Product hierarchy no. *				Part no.	SBU	Type / Description	Customer part no.
SBU	PG	PUG	Type				
80	084	002	0000006146	See list below	EMC	FMLB-09

Product Change Notification					PCN FMLB-09 case 73 redesign		
owner	creation date	release date	released by	change order no	rev	page	D10-047-007
segatro	03.07.2020	10.07.2020	blumhe	2020132	A	1 of 2

Old product appearance	New product appearance

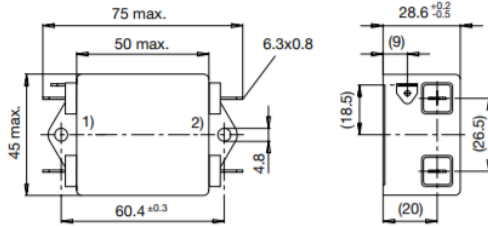
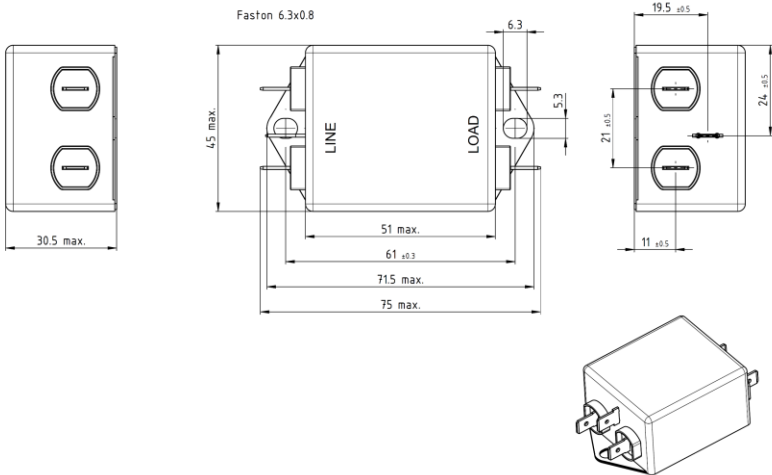
- Nickel plated steel case instead of aluminium case
- Different shape and position of external quick connect terminals
- Different position of earth terminal
- Different fixing center distance

- Change of product appearance due to new nickel-plated steel case instead of aluminium case
- New case is provided with a bottom cover
- Moved position and different shape of plastic part for external quick connector terminals
- Moved position of earth terminal
- New elongated mounting hole with different distance 60.4 ±0.3 to 61 ±0.3 fits old mounting dimensions
